Mixed Use Residential (Tourist) Flat Building (MP09\_0016)

Director-General's Environmental Assessment Report Section 75I of the Environmental Planning and Assessment Act 1979

August 2012

Figure 7: Floor plan layout of original EA proposal (Source: Environmental Assessment)

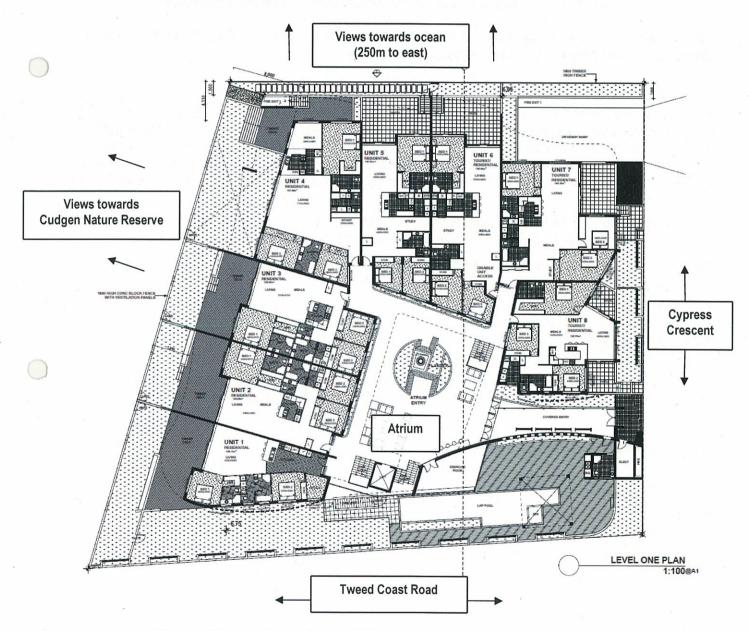
The PPR proposal included significant urban design changes from that publically exhibited. The key design amendment has been the removal of the atrium (see Figure 7) and the corresponding reconfiguration of the building layout. These changes resulted in a building frontage which better addresses the street corner at Tweed Coast Road and Cypress Crescent and which better articulates the street hierarchy. The building frontage, which includes external balconies, now serves to activate the street which vastly improves this aspect of the proposal which was formerly set back from the street corner.

Figure 11: Privacy impacts of EA proposal on 8 Cypress Crescent (Source: Environmental Assessment)

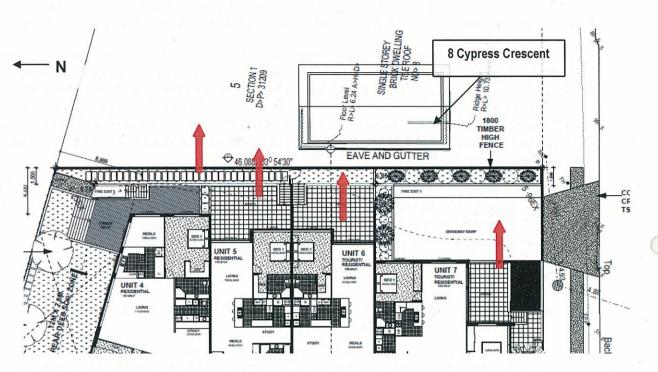
The department raised concerns regarding the original EA proposal as it was considered to raise privacy impacts to dwellings in Cypress Crescent to the east of the site. 8 Cypress Crescent is setback some 2m from the common boundary as seen in Figure 11 below. Although no neighbour objections were received, the proposal would introduce a 3 storey building into an area characterised by one and two storey dwellings and immediately adjacent a single storey detached house.

The PPR proposal subsequently addressed the privacy concerns with a realignment of the building layout. The apartments located closest to the eastern common boundary now have a northerly aspect, which substantially reduces overlooking into 8 Cypress Crescent. Privacy screens are proposed on ground, first and second floors facing 8 Cypress Crescent. To ensure privacy to 8 Cypress Gardens is maximised, the department recommends an additional planning condition restricting the downward view from the kitchen windows on the first and second floors facing east. The proposed PPR layout is seen below in Figure 12.

Figure 13: Non-compliance with SEPP 65 – Ground Floor Terraces (Source: PPR)

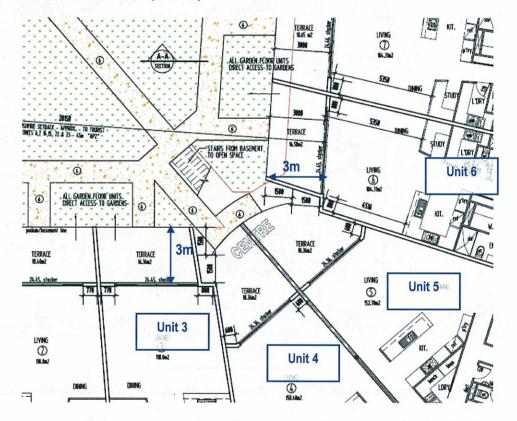
A non-compliance issue arises regarding private open space for ground level apartments. SEPP 65 requires that private open space is provided for ground floor apartments with the provision of a terrace of at least 4m in depth. As seen in Figure 13, the proposed ground floor apartments have a terrace depth of 3m. Non-compliance with the SEPP is considered acceptable in this instance however, as the design of the building does not allow for ground floor terraces to exceed 3m. If the depths of Units 3 & 6 were to be extended, this would result in an unacceptable reduction to the balcony amenity to Units 4 & 5.

Figure 14: Non-compliance with SEPP 65 – Access to Street from Ground Floor Dwellings (Source: PPR)

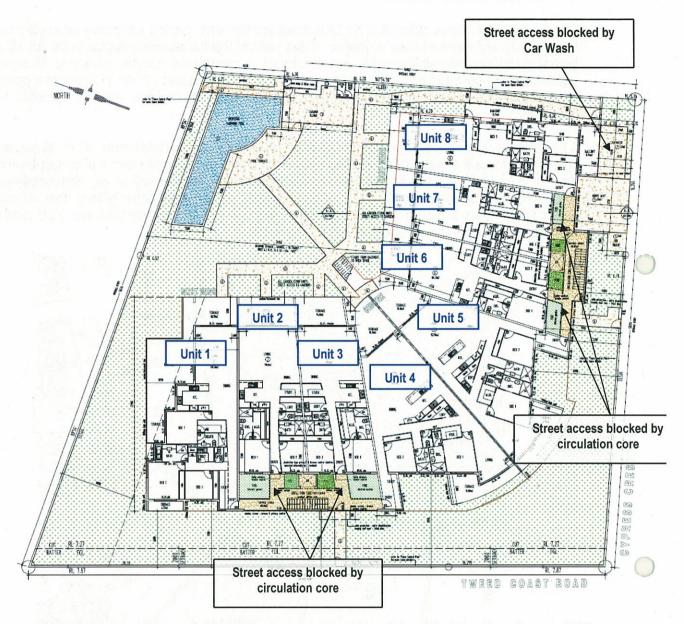
SEPP 65 also seeks that ground floor units have access to the street. The design intent is to activate the streetfront however the PPR proposal does not provide such street access. The proponent argues that the two circulation cores proposed for each street frontage effectively restricts ground level access, while the car wash and basement car parking on the Cypress Crescent frontage prevents further opportunities for street access (see Figure 14). Accordingly, as 5 of 8 ground floor units (Units 2, 3, 6, 7 & 8) have their street level access restricted by the building design, it was considered undesirable to incorporate street level access into the final design. The department agrees that the provision of street level access to the remaining 3 units (Units 1, 4 & 5) would be incongruous to the overall design.

© NSW Government August 2012 Despite two areas of non-compliance with SEPP 65 design guidance, the department supports the PPR proposal. Overall, the requirements of SEPP 65 are met or exceeded and residential amenity is ensured for both occupants and neighbouring properties. A detailed table outlining compliance against the requirements of SEPP 65 is contained within Appendix C.
